**RE: Lot 13 Block 3 Unit 19 Volcano Cliffs Subd.
6515 Camino Del Oeste NW
Request for Permanent C.O. - Not Accepted
Engineers Stamp Date 7/6/16 (D10D003U13)
Certification Dated: 1/30/17**

GRADING AND DRAINAGE PLAN

LOT 13 , BLOCK 3 , UNIT 19 , VCS

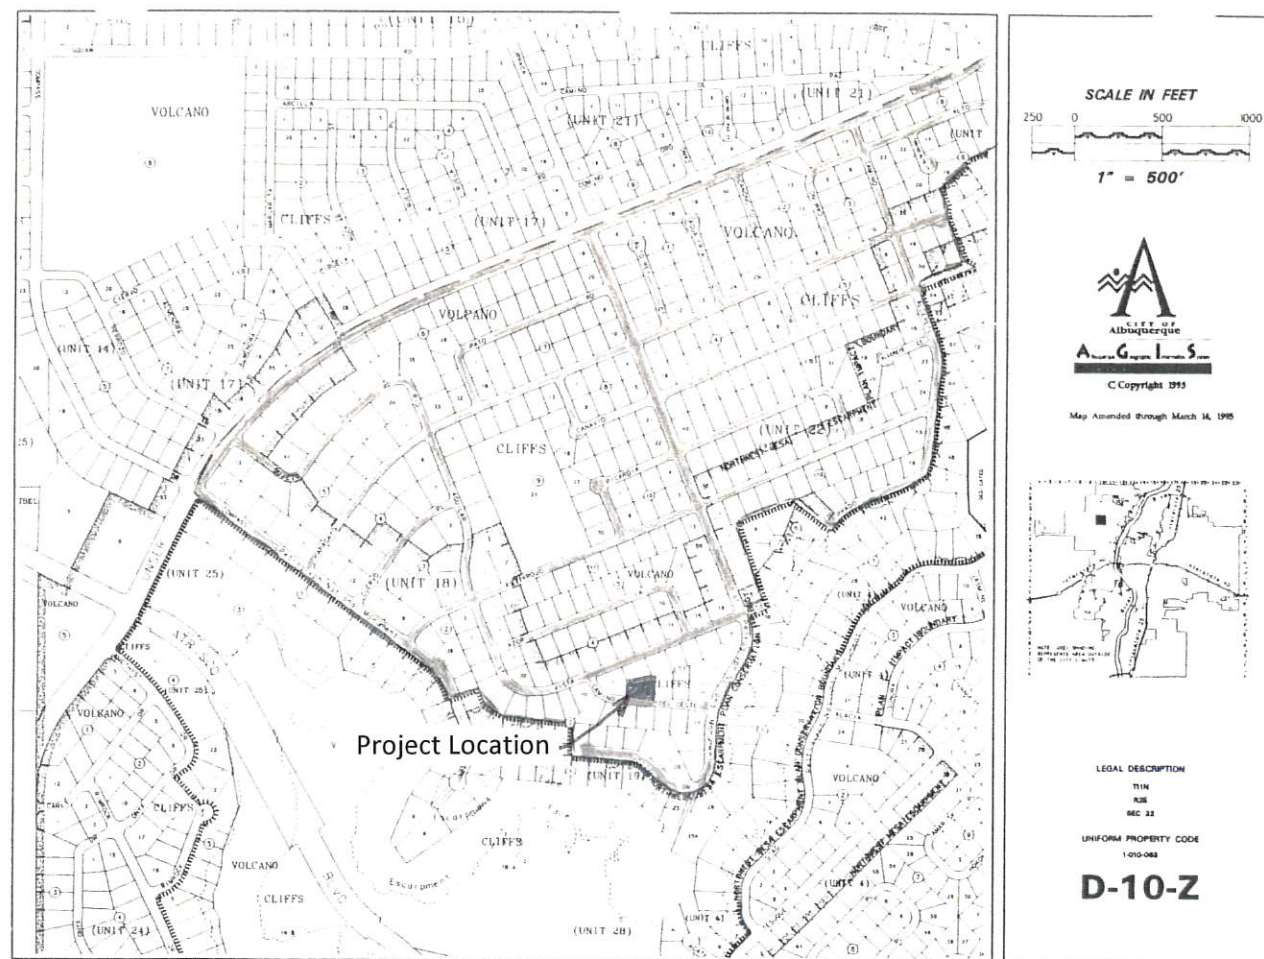
- Per the approved site plan the flow on the east side of the lot is to drain south toward the front yard pond. The lot is graded to drain north. The flows need to be reversed.
